2ND AND VIRGINIA

A new mixed-use hotel, residential, and co-working building will be located at the corner of 2nd Avenue and Virginia Street in downtown Seattle. The building will be a vibrant addition to this key intersection and will take design cues from the existing landmark on site and the urban patterns of buildings and pedestrian experiences that make up the Belltown neighborhood.

RESPONSE TO BOARD GUIDANCE

1 ADDITIONAL VIEWS

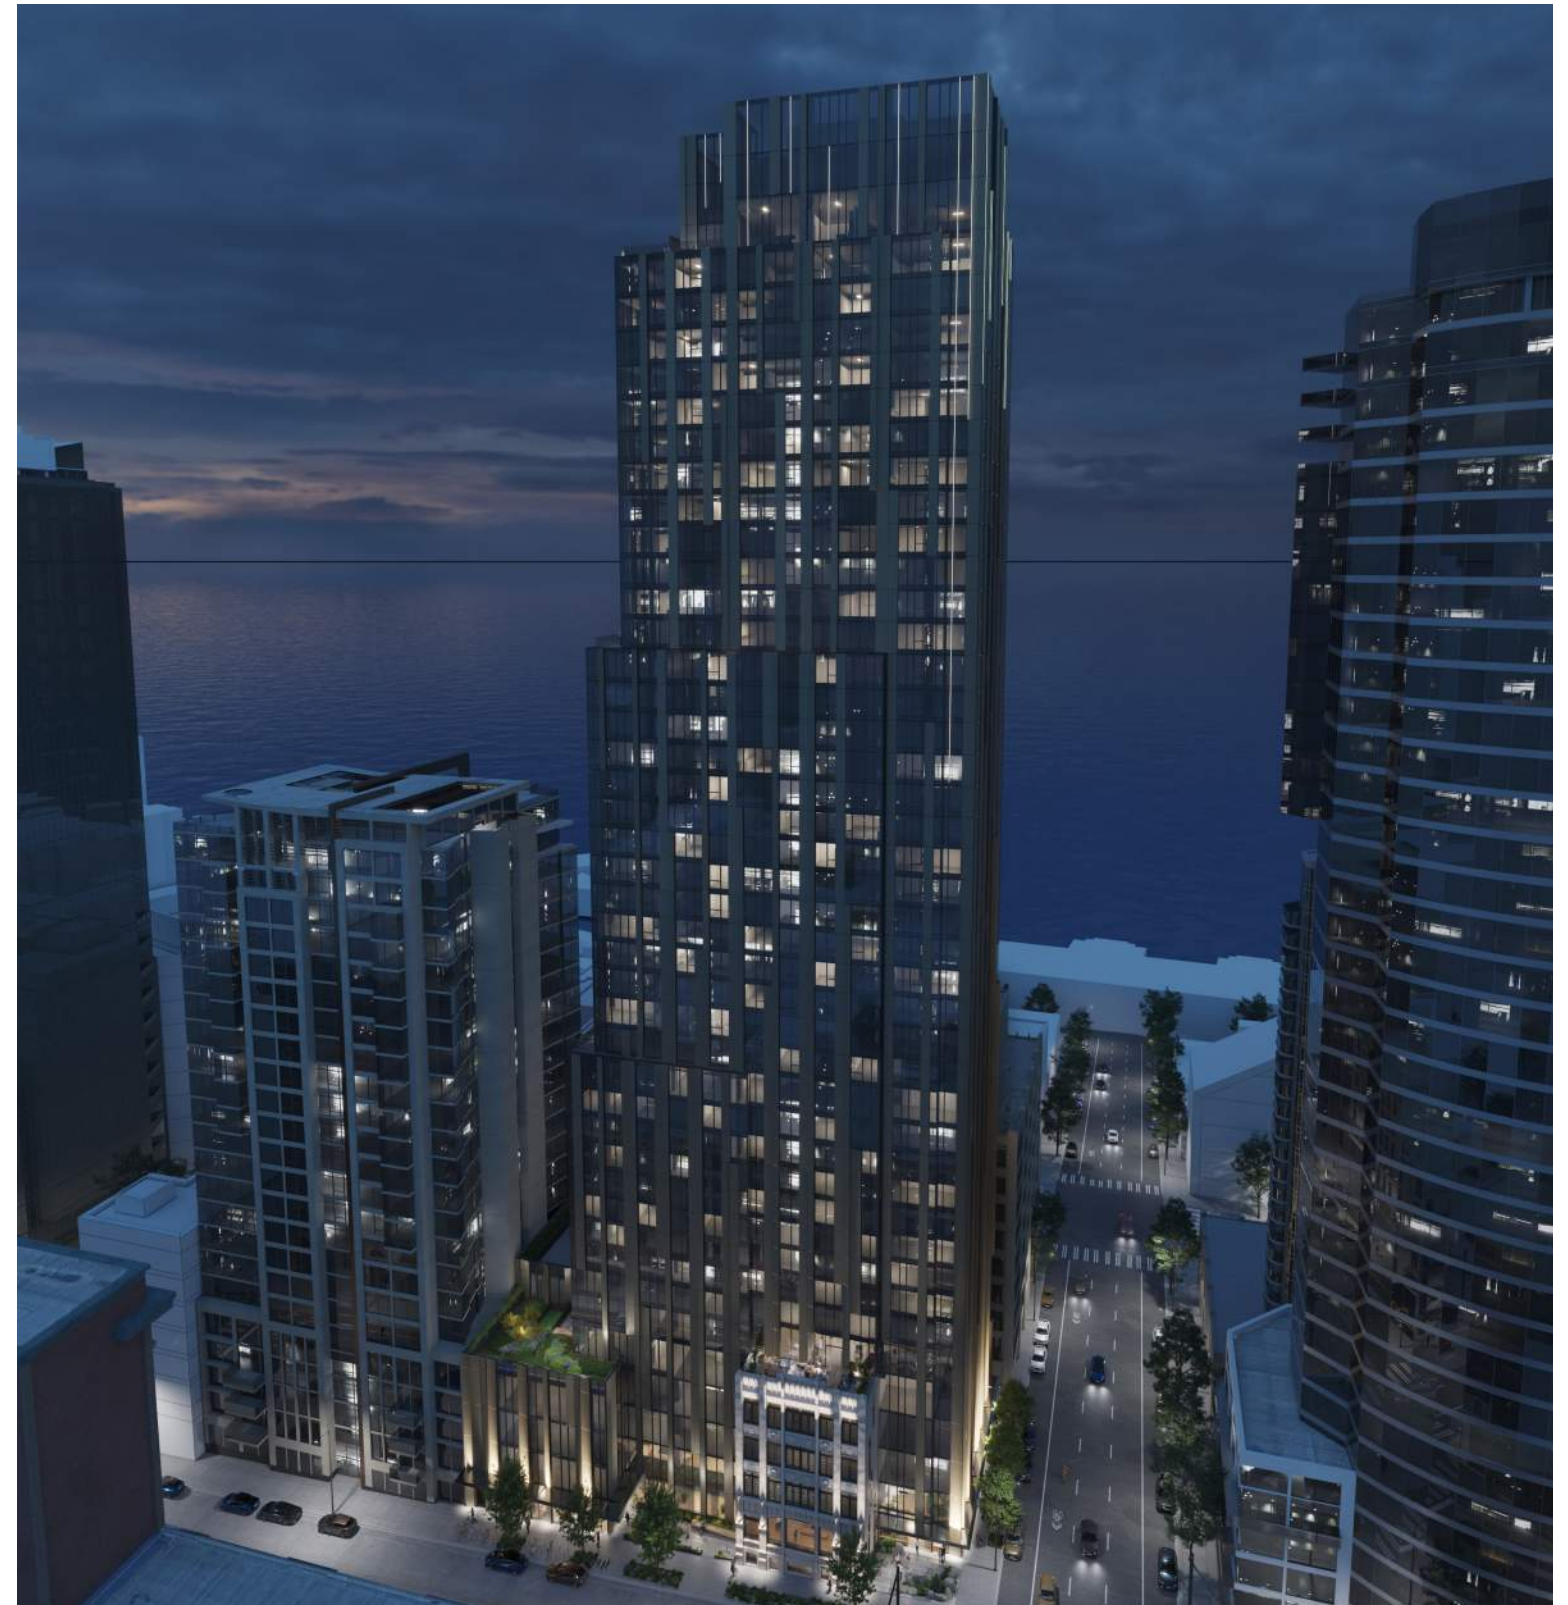
The Board appreciated the additional views, page 24 for example, provided by the applicant team. The Board would like to see these views (night and day) provided at the next meeting, illustrating how the tower top has been further enhanced to add to the skyline and support the building identity. The Board would like to see the materiality of adjacent buildings in future images as this will inform guidance related to how the tower sits within the skyline context.

The design team has provided several overall and tower top renderings in both night and day conditions with the context of adjacent buildings.

2 APPROPRIATELY SCALED TOP

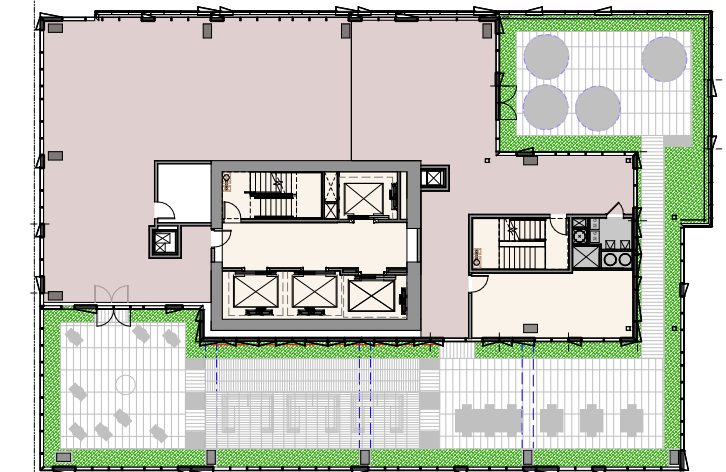
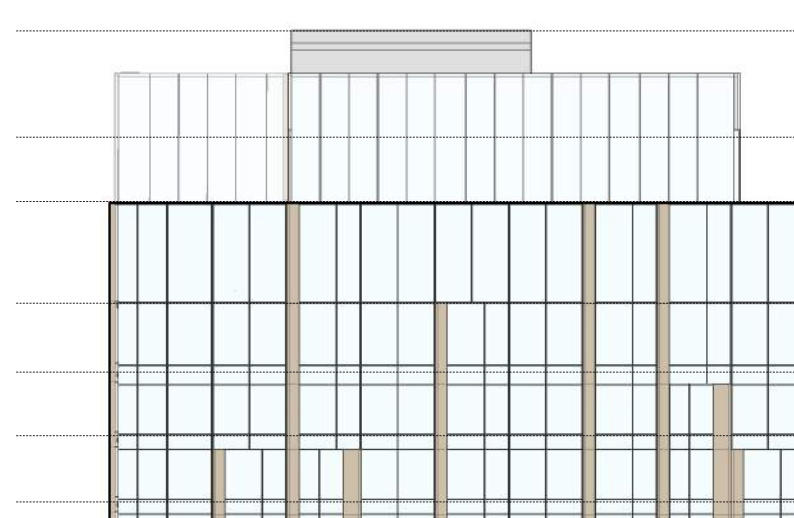
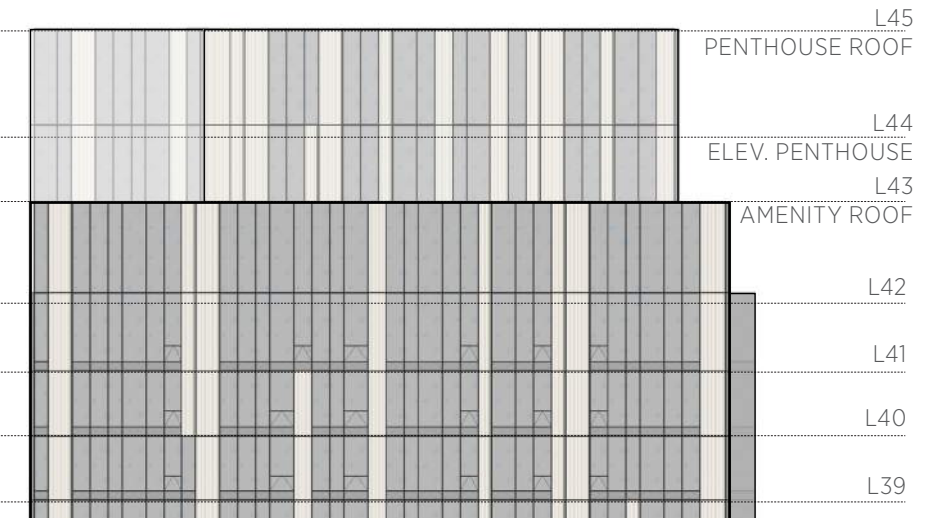
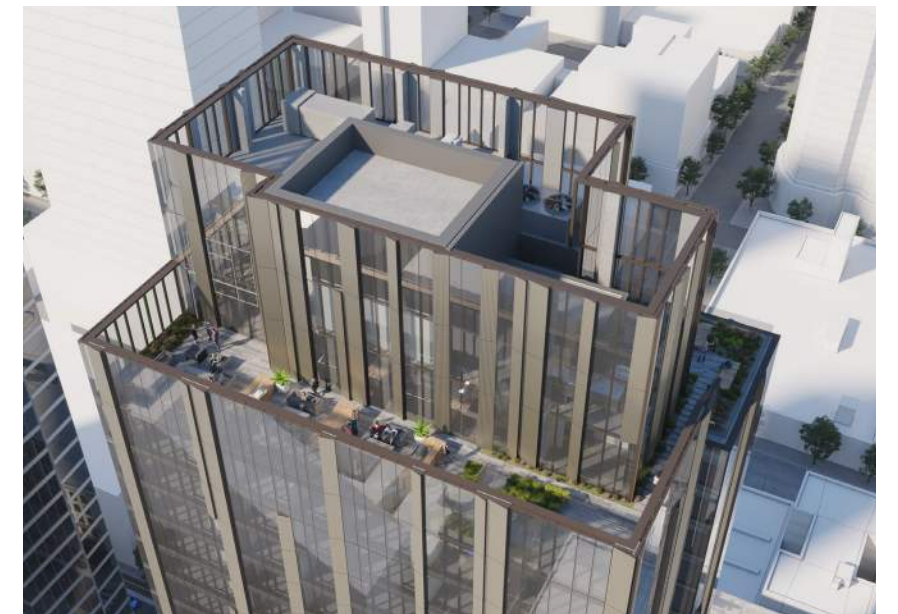
The Board expressed some concern with the tower's top terminus, providing guidance to further refine the tower top to be more in keeping with the design rules (stepping concept) established by the body of the tower form. The top should be scaled appropriately (large enough massing moves) to create a logical terminus form in keeping with the tower proportions and form.

Massing: In order to simplify the rooftop massing, the facade has been raised to cover the elevator/ core overrun, enclosing all mechanical equipment within one expression, which originates at the ground and extends up toward the sky.

Facade: In contrast to the opacity seen in the previous EDG scheme, the tower terminus' west facade has been broken down into a lighter but still continuous facade treatment. The current design has evolved to bring the solid facade patterning created by the metal panels to the top of the screening wall.

3 SOUTH PARTY WALL

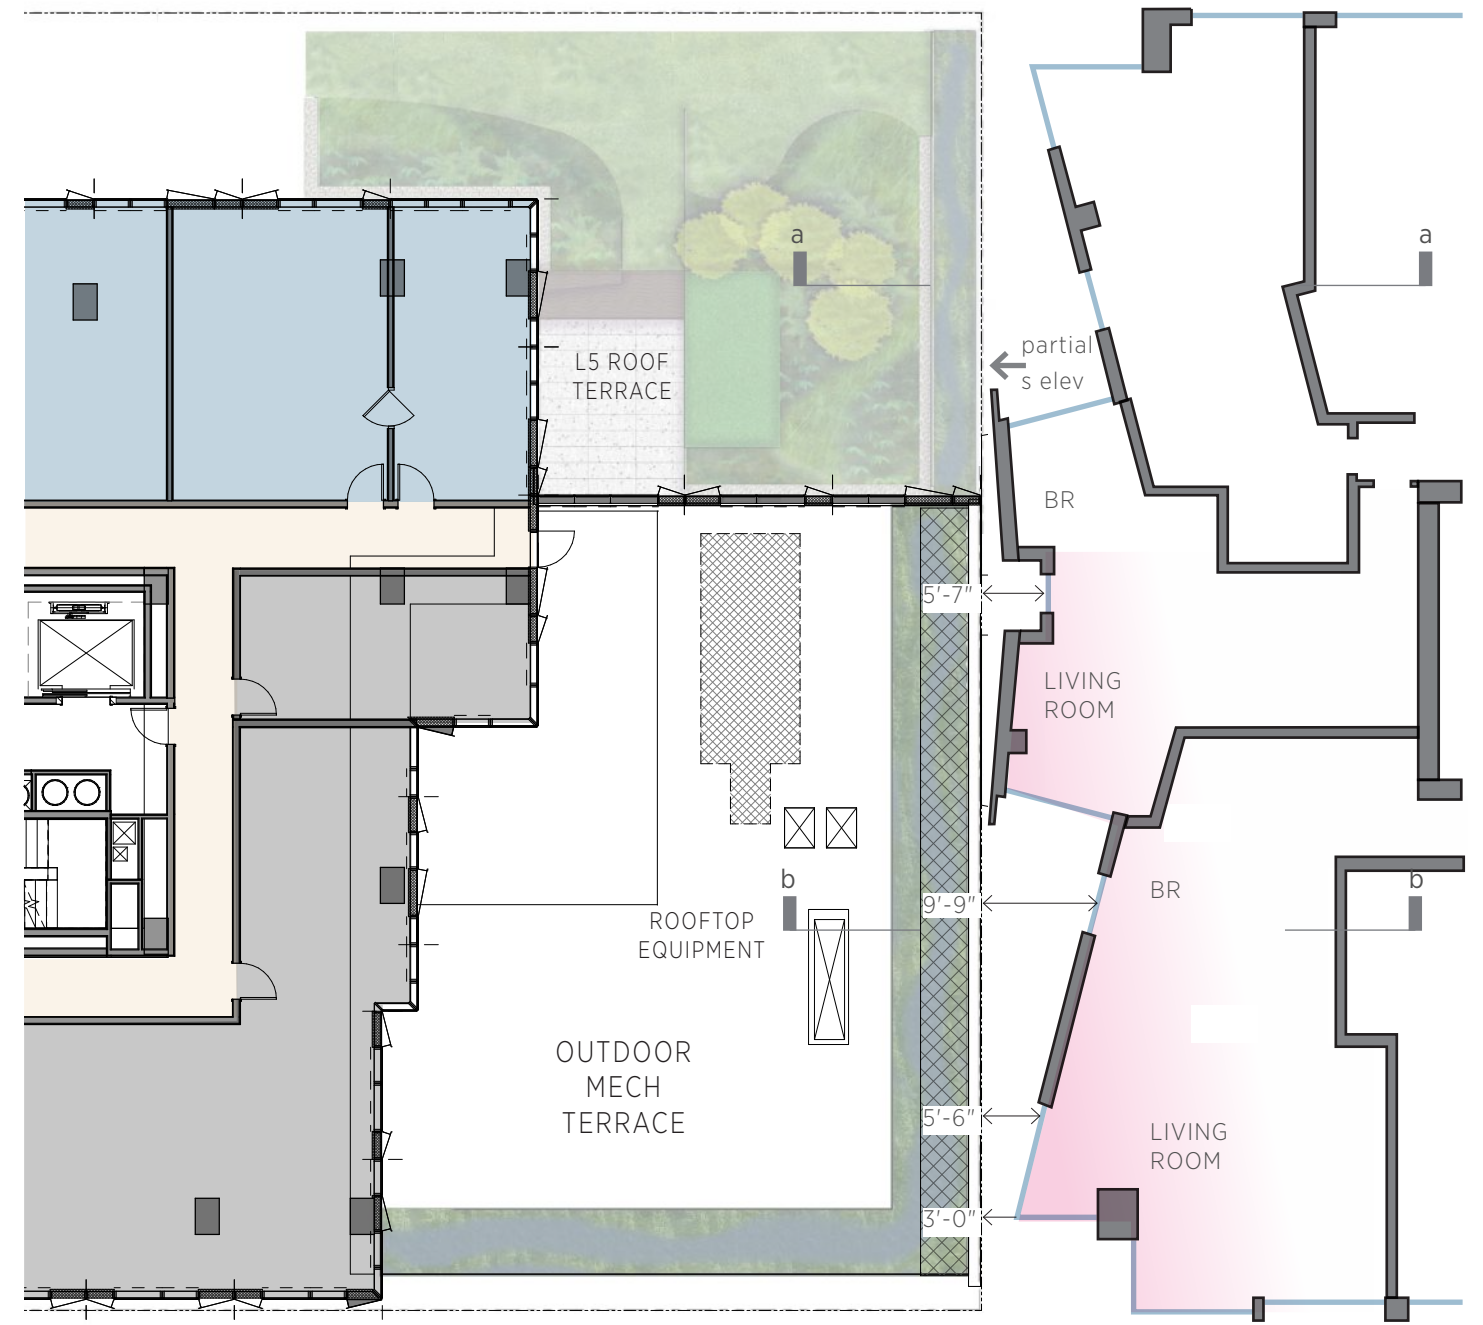
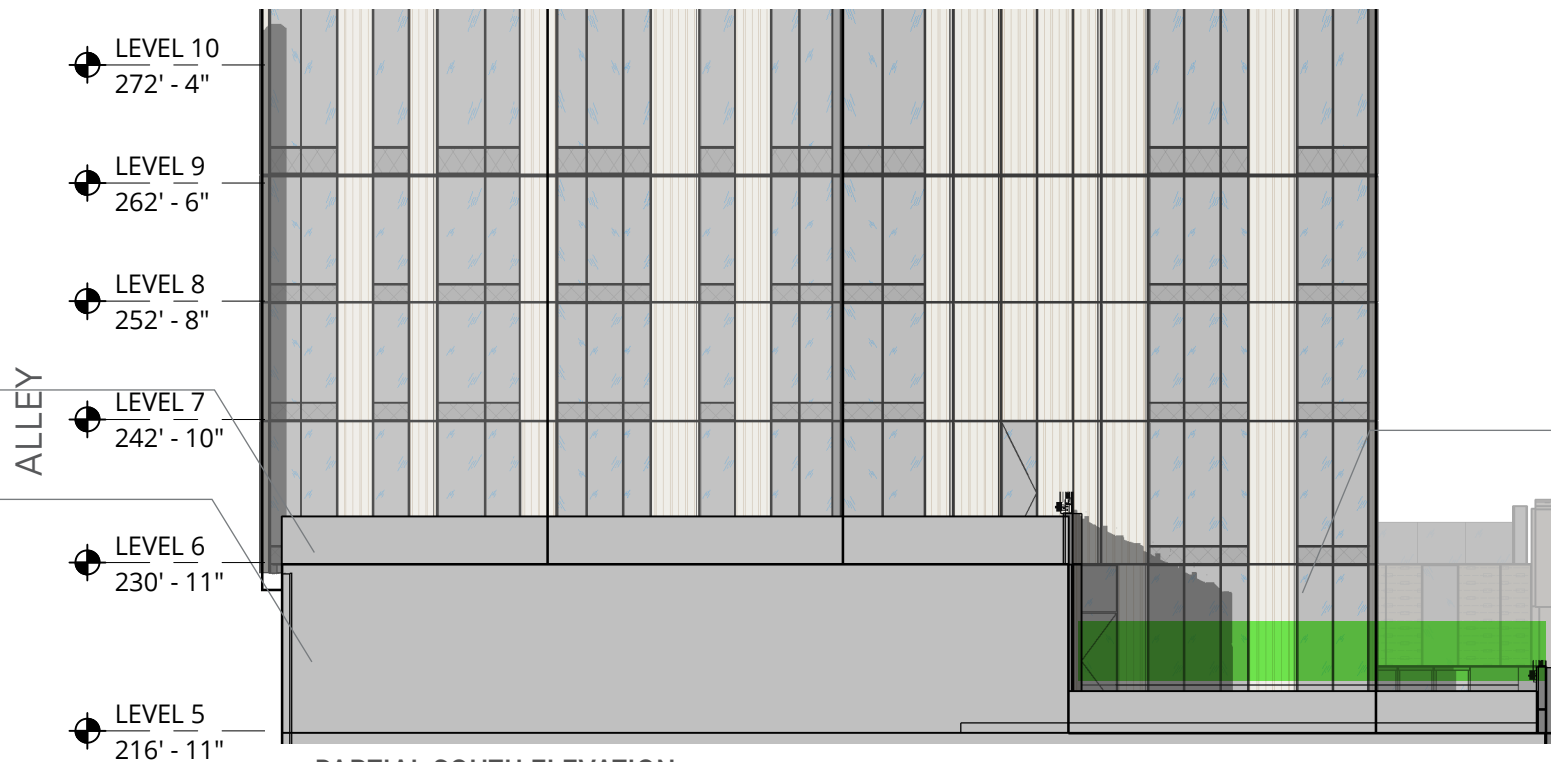
At the next meeting, the Board requested more information detailing the resulting party wall condition along the south edge.

In addition to the tower setback on the south, the design team has made respectful considerations to the abutting property. The project proposes an outdoor roof terrace at the southeast corner on Level 5 with a five feet deep landscape buffer. This buffer will be a pleasant view from the neighboring property, and provide visual and audible privacy between the buildings. As the building steps to Level 6 at the west, another 5' deep landscape buffer is proposed, along with an acoustical barrier to mitigate any mechanical noises transference to the neighboring property. One unit of the neighboring building will face a natural party wall.

4 VERTICAL LANGUAGE

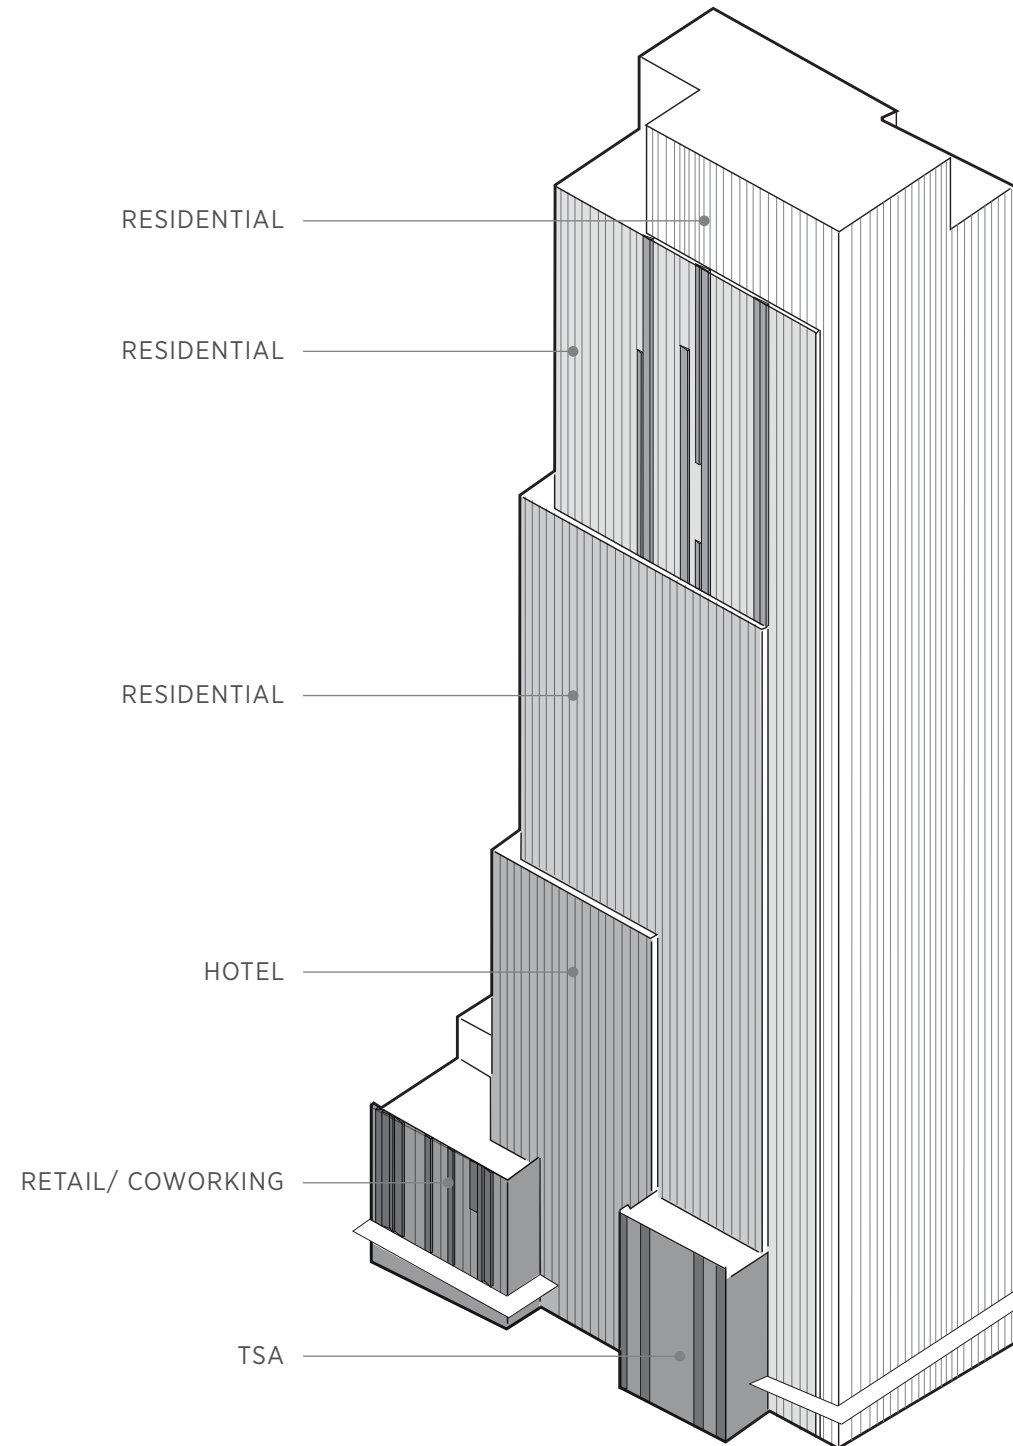
Moving forward, the Board provided guidance to demonstrate how the vertical language of the tower would be carried down through the street-level expression.

The tower's telescoping form is informed by programmatic transitions throughout the tower's mass, and expresses its three key uses: retail/ coworking, hotel and residential, emphasizing the tower's mixed-use nature.

Angled facade panels reference historic pilasters on the landmark Terminal Sales Annex Building below, further reinforcing the tower's connecting to street level as well as its past. Subtle changes in the panel texture reinforce the massing strategy.

With its unique facade panels, originating at the ground and reaching vertically up to the sky, the project strives to become a wayfinding device within the city.
